HAZEL

SUITE 136 BUILDING B

CONSTRUCTION SUMMARY

Forestside Estates Inc.

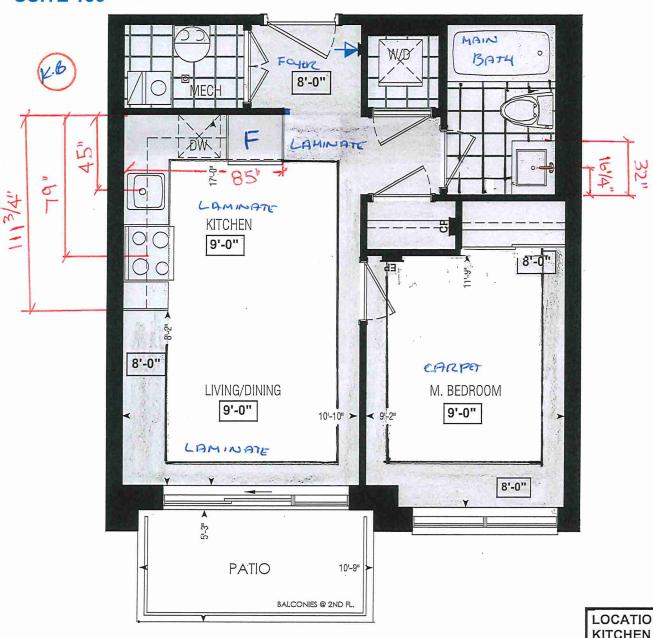
LOCATION OF KITCHEN LIGHTS REFER TO KITCHEN DWG.

STOVE & SINK WALL ELEVATION 1A, 1Aa

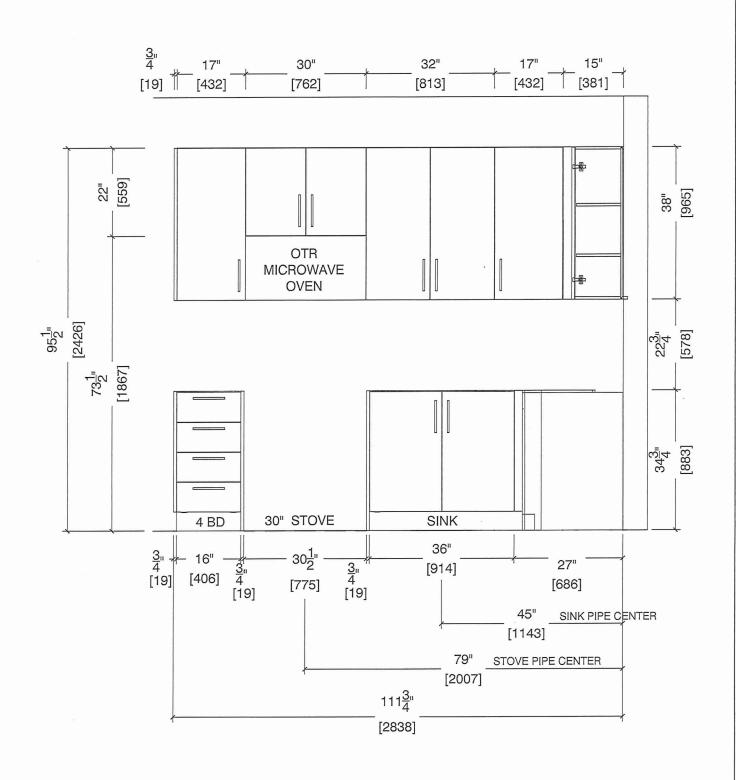
1 - KITCHEN- PLUMBING - Install the UPGRADED UNDERMOUNT sink in the kitchen- Install the BLANCO QUATRUS U1- Model # 401273. To include cut and polish (see sketch)
